ARBORICULTURAL IMPACT ASSESSMENT AND PRELIMINARY METHOD STATEMENT

For the proposed development of
Land East of Tilletts Lane, Warnham, West Sussex

Prepared For:	The Lucas Broadbridge Heath Trust
Local Authority:	Horsham District Council (HDC)
Document reference:	MDJAC-24.025-AIAPMS-01A
1st Issued:	9 June 2025
Revision:	A – 23 January 2026
Author:	Matthew Jones BSc (Hons), MArborA

S2. This is Revision A of the original document produced in June 2025. It has been produced in response to consultation comments made by the local authority's arboricultural officer, which are addressed directly at Section 6. The principal change to the tree protection plan relates to the inclusion of an updated surface water drainage strategy in proximity to an off-site oak tree (T59), which seeks to minimise impacts. The necessary amendments relating to the construction methodology for this element, and an alternative construction method for the road itself, have been updated throughout the report.

6.1 RPA INCURSIONS

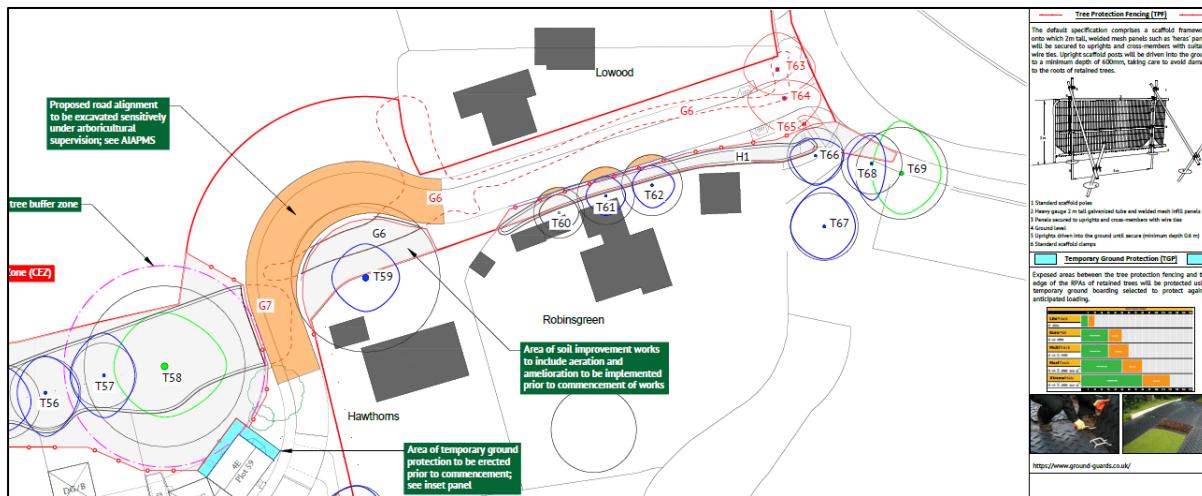
6.1.1 The following comments were made by Mr Andrew Bush, Arboricultural Officer at Horsham District Council, in relation to the previously proposed RPA incursions:

The proposed RPA incursions are, for the most part, below the 20% threshold typically considered acceptable under BS5837. However, it is noted that no overriding justification appears to have been provided to demonstrate why works within RPAs are required. Furthermore, all the RPA incursions all currently propose excavations for the access paths and roads, rather than adopting less invasive above-ground construction methods. This is unsatisfactory; above-ground solutions should be considered wherever feasible, and where they are not, clear justification must be provided.

Para 4.6.2 of the BS advised – “The RPA for each tree should initially be plotted as a circle centred on the base of the stem. Where pre-existing site conditions or other factors indicate that rooting has occurred asymmetrically, a polygon of equivalent area should be produced. Modifications to the shape of the RPA should reflect a soundly based arboricultural assessment of likely root distribution.”

Due to the constraint posed by the change in land levels and the parking area to the south of T59, it would imply that the tree’s principal rooting area lies to its north, beneath the compacted trackway/PROW, where the new site access is shown. Whereby, the long-standing parking area to the south has most likely impeded any significant root development in that direction and, in itself, constitutes a significant proportion of hard surfacing within T59’s RPA, as indicated on the Tree Protection Plan. When combined with the proposed 8.8% incursion, the cumulative extent of hard surfacing within the RPA would exceed the tolerable limits of 20%, as advised in the BS.

6.1.3 The justification for avoiding the incursions into the RPAs of T36 and T37 relates to existing ground levels, which rise from the road on the western boundary. In order to formalise access on this boundary, which is a planning requirement, an existing informal footpath has been identified as the least impactful location. By re-using the existing location, impacts to the larger, more prominent and higher quality trees further to the north will be avoided. However, the existing ground levels make non-invasive, above-ground solutions

6.1.6 To overcome the ambiguity regarding the likely modifications to the RPA required by the hard surfacing and the drainage strategy, two significant changes have been made to the proposal.

6.1.10 Once the drainage elements have been installed, the circular area of road highlighted by **purple hatching** on the TPP will be installed using a suitable cellular confinement system such as CellWeb. Whilst some minor sensitive excavation will be necessary to remove the existing turf layer and organic root masses to form a suitable level on which to construct the road, existing levels will be broadly maintained, and the road built up from this level.
